BID ADDENDUM

PROJECT NUMBER	PROJECT TITLE		
23-02258	Queens Elevators – Watson Hall		
PROJECT LOCATION / ADDRESS		DATE ISSUED	ADDENDUM #
Watson Hall, 49 Bader Lane, Kingston ON		April 29, 2026	04

Architectural Addendum No. 4

Queen's Elevator Project – John Watson Hall Kingston, Ontario

Scale: 1:25
Drawn By: Author
Reviewed By: Checker
Revision No.: 12
Plot Date: 2026-04-28
Drawing No.: A7.40

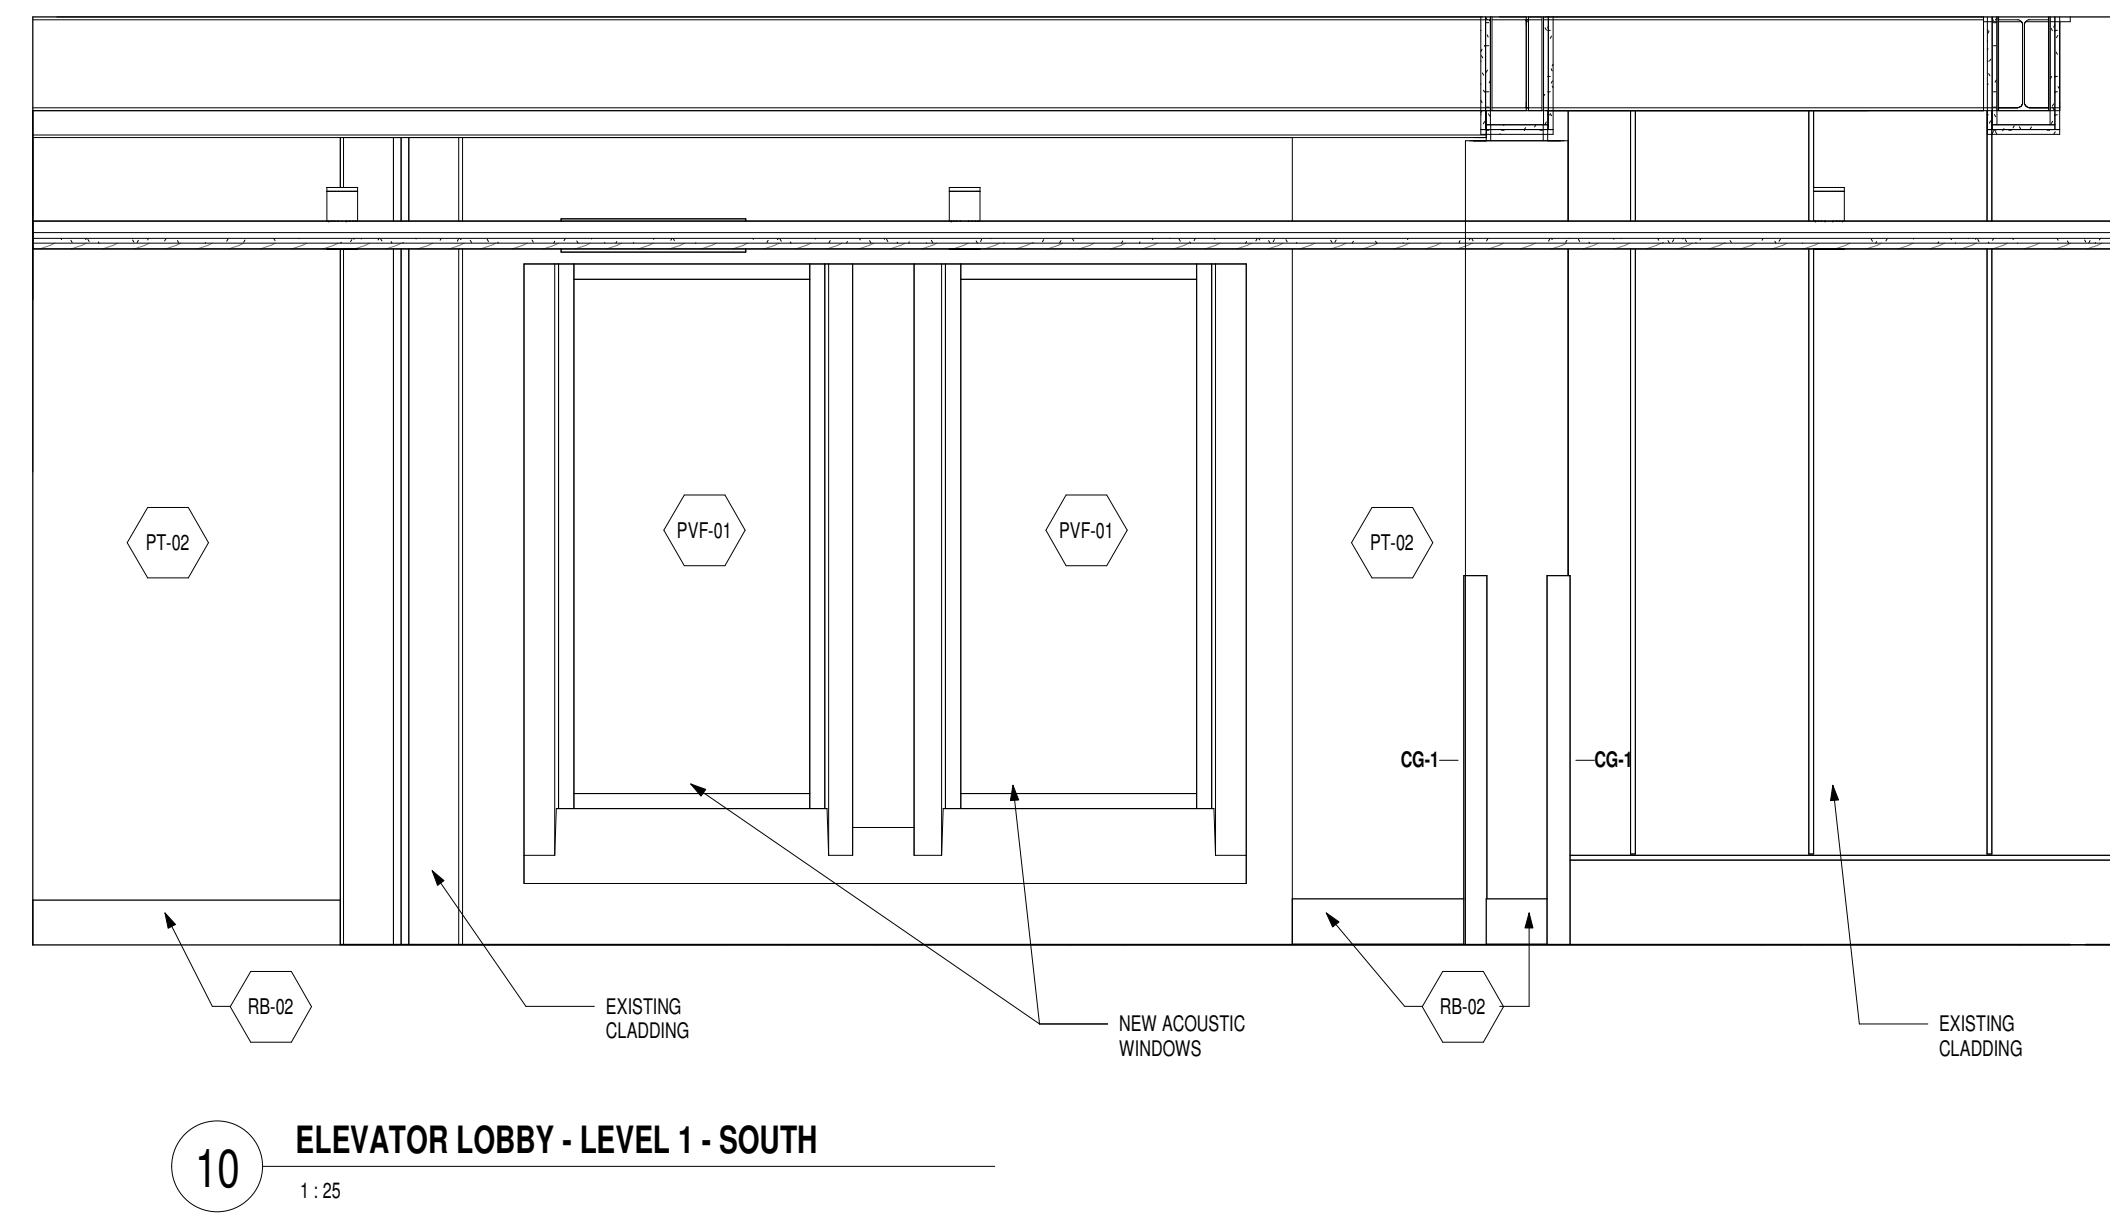
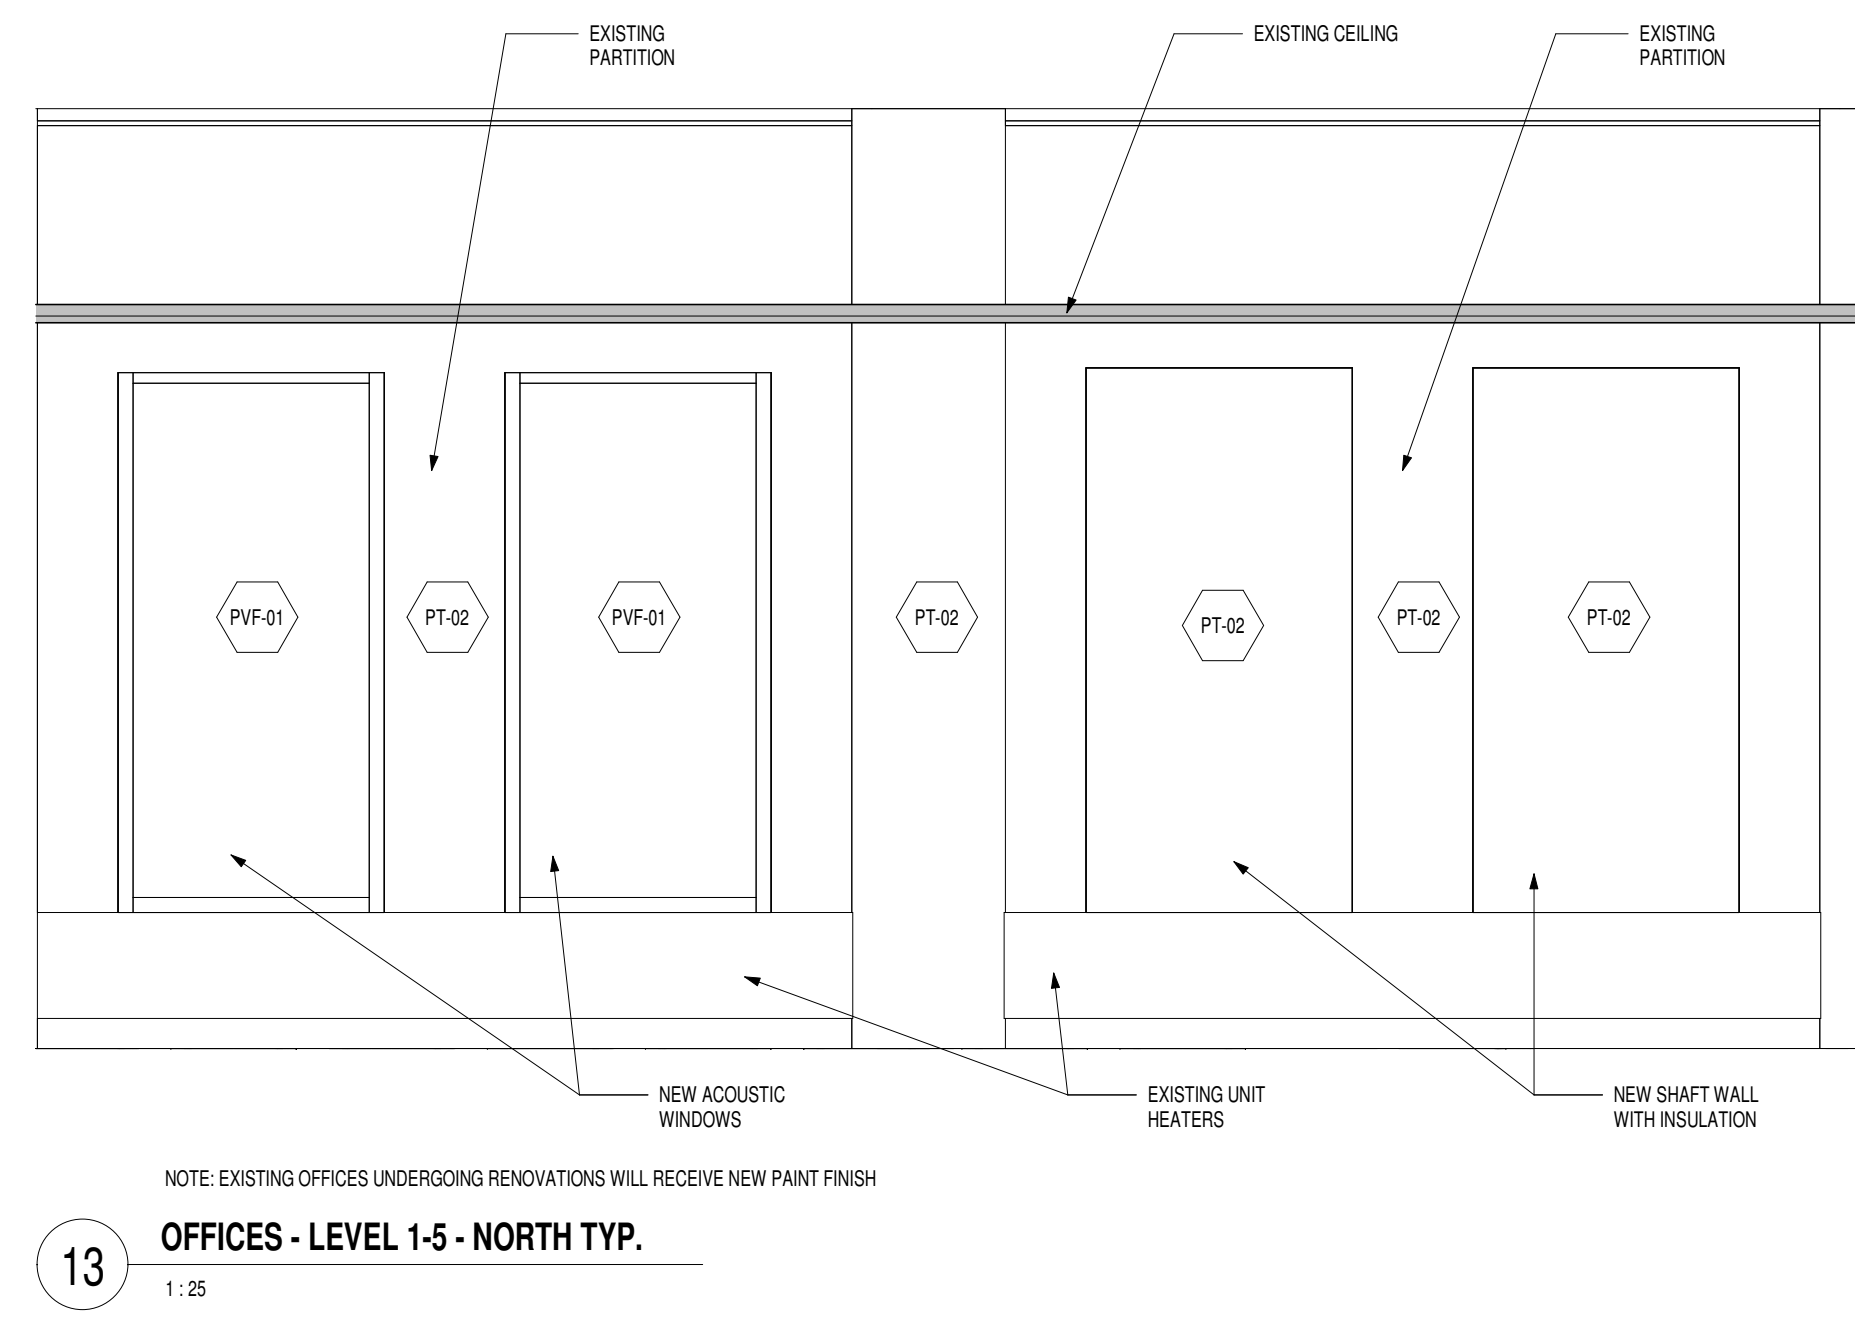
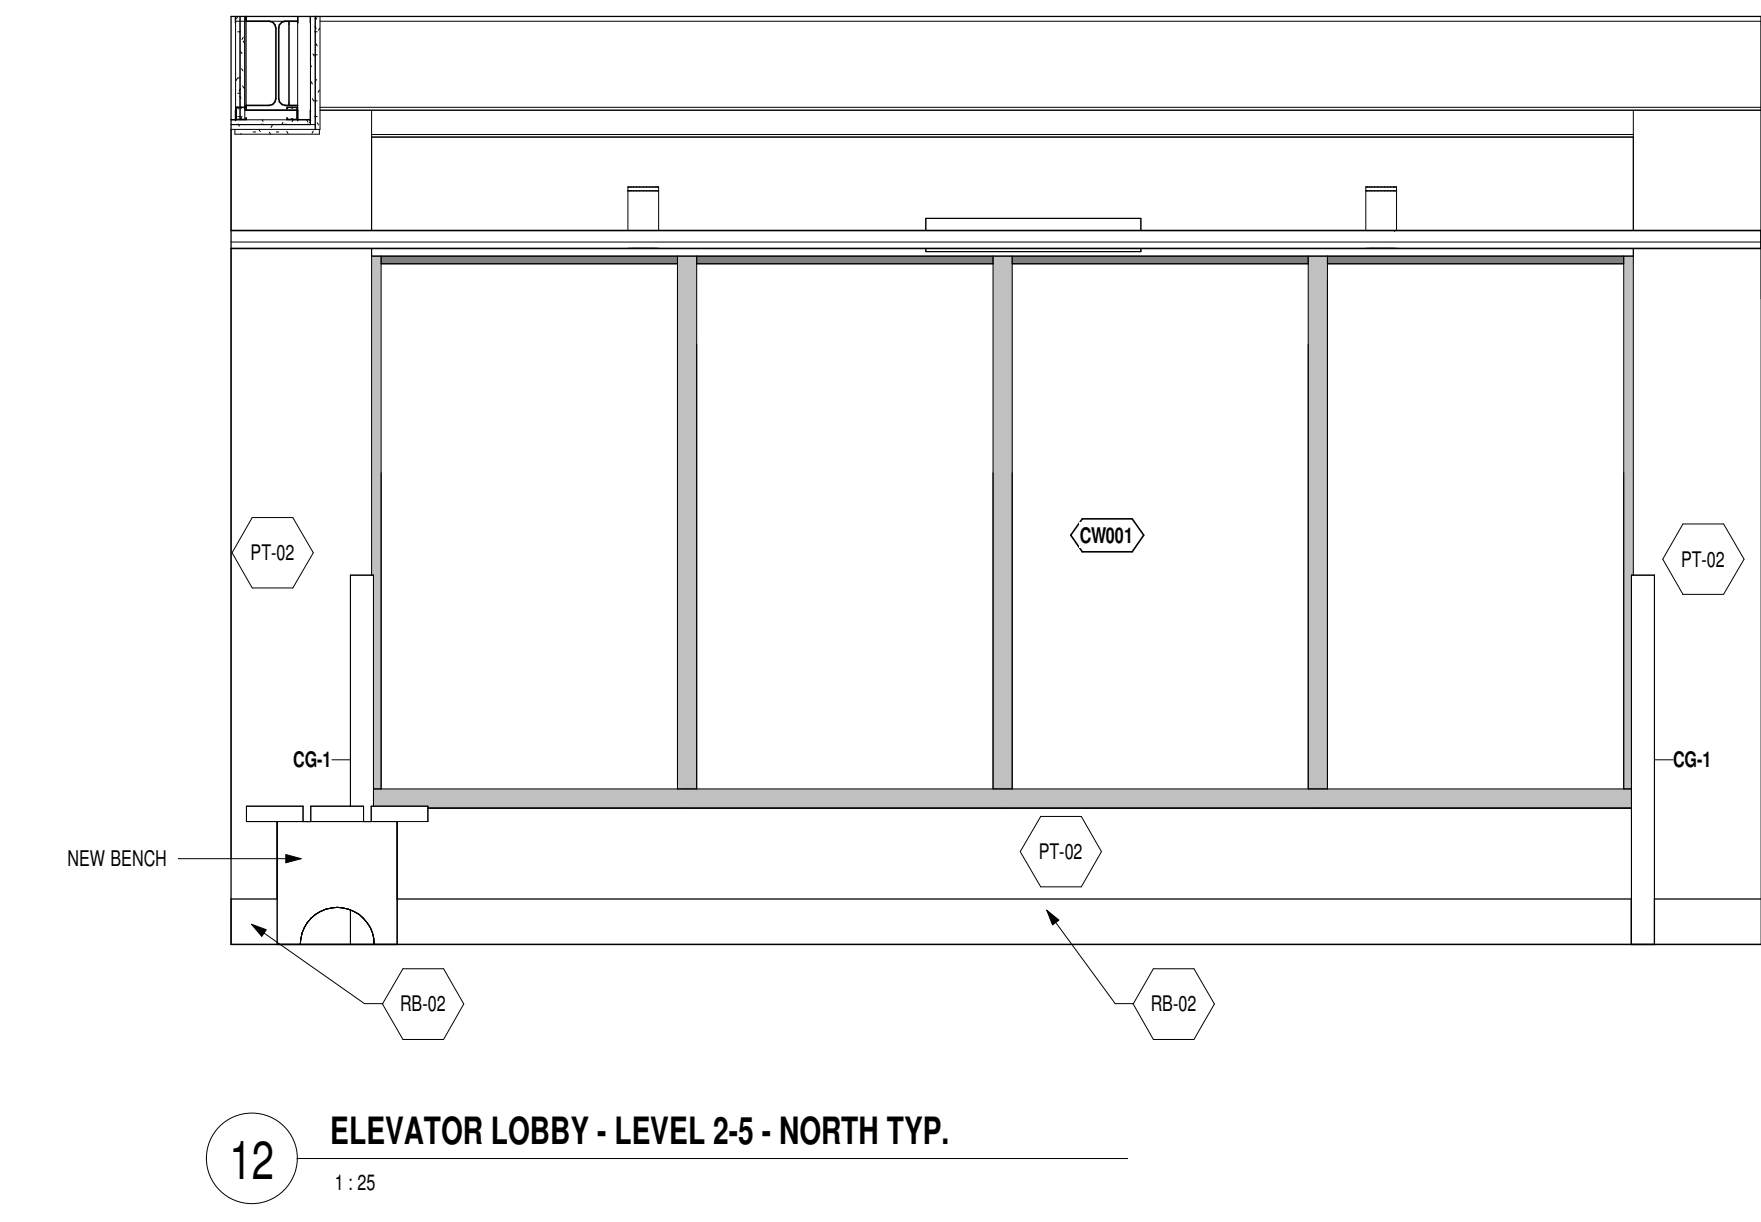
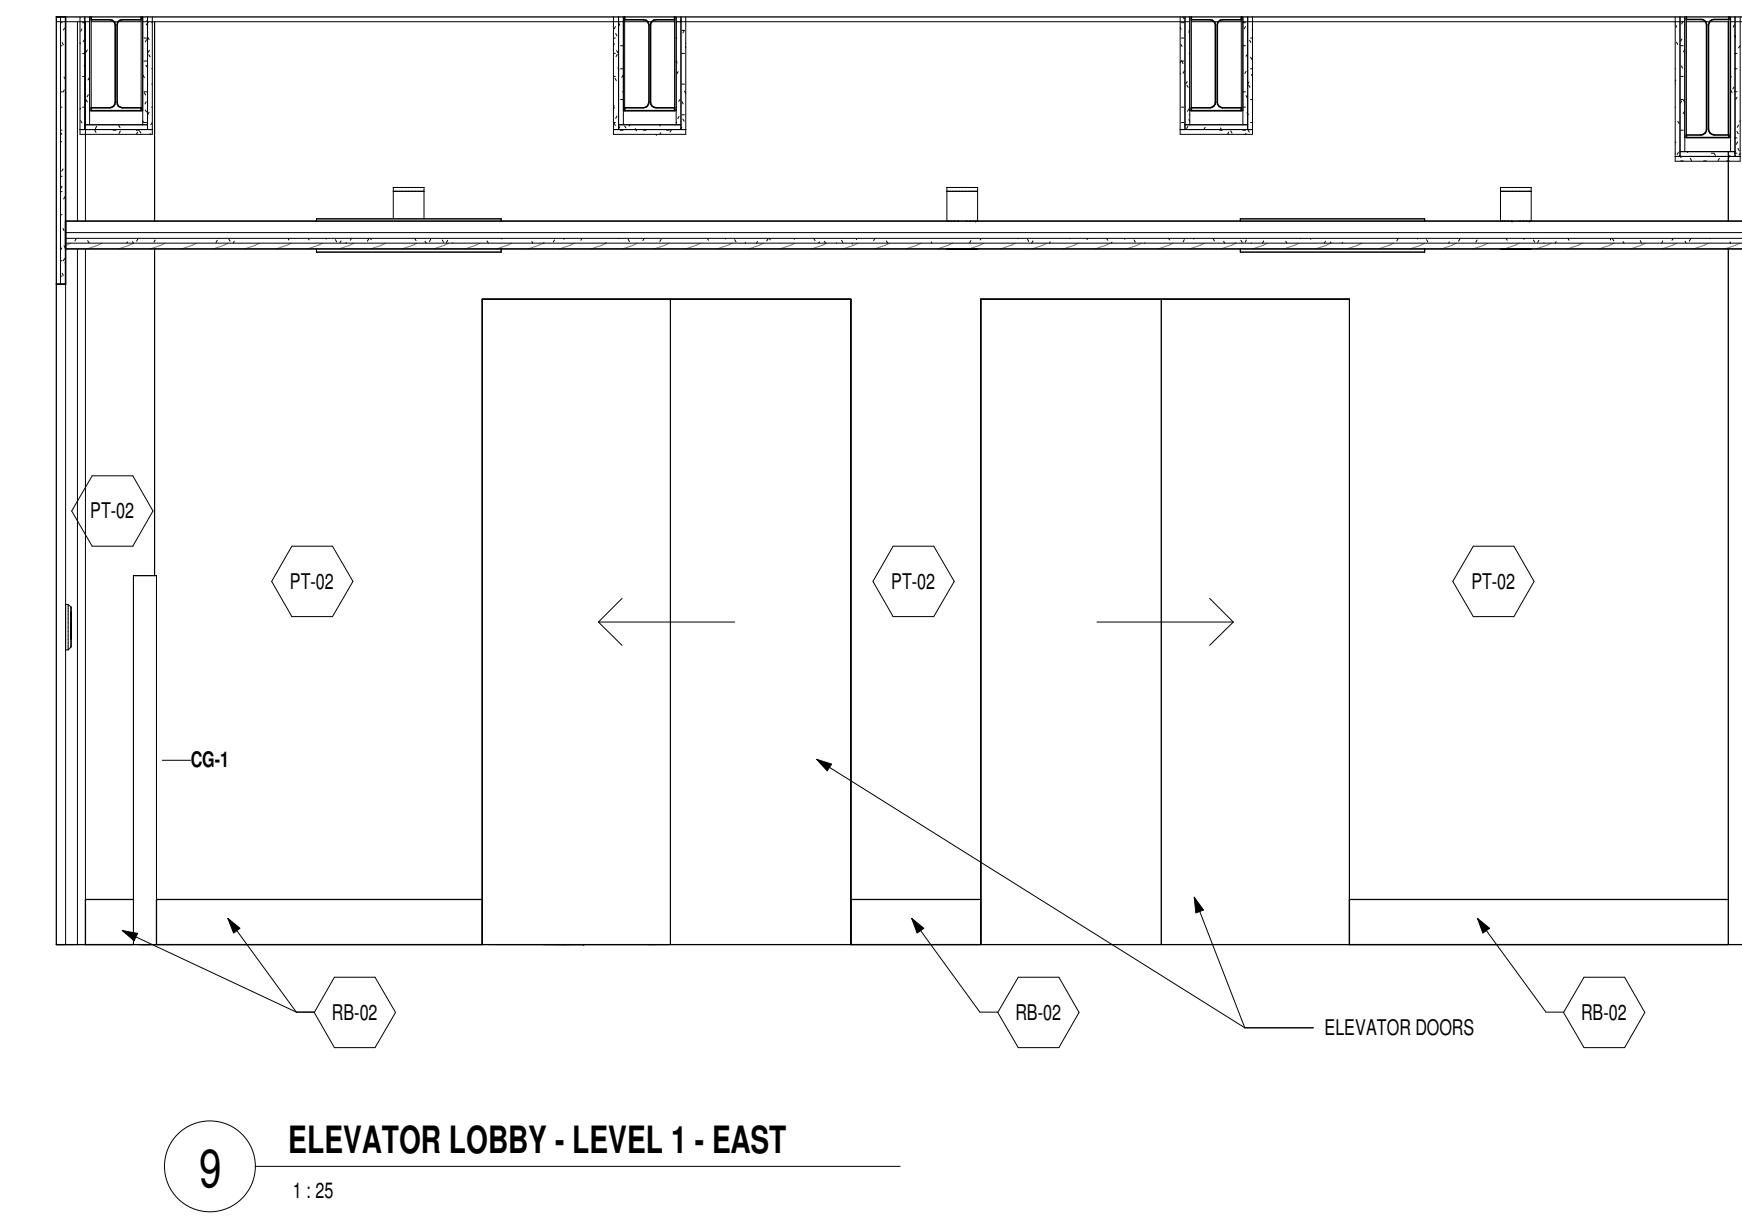
A.1 Update RB-01 and RB-02 notes to clarify the basic of design products and finishes in A7.40.

Answer: Basis of design products and finishes are added to RB-01 and Rb-02 notes. Refer to attached A7.40.
